1. Antennas

1.1 Information for all the antennas, i.e., type, gain and relative positions within host, must be included in the filing

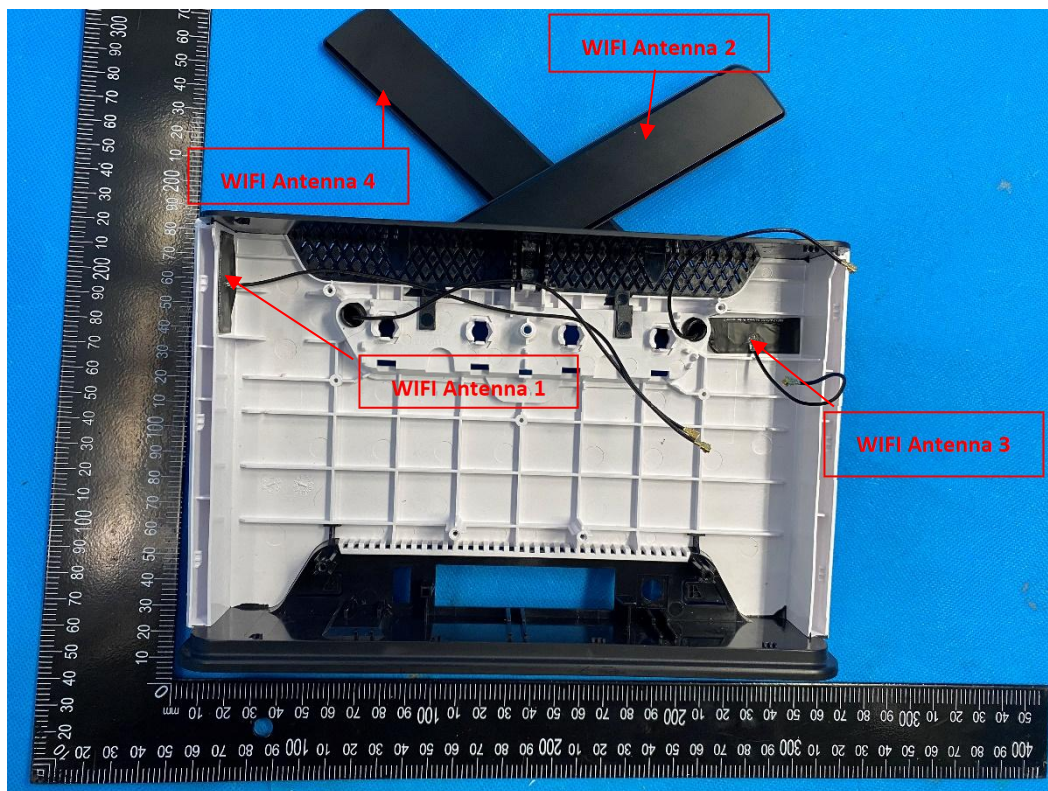
The antenna information and antenna position diagram are as follows:
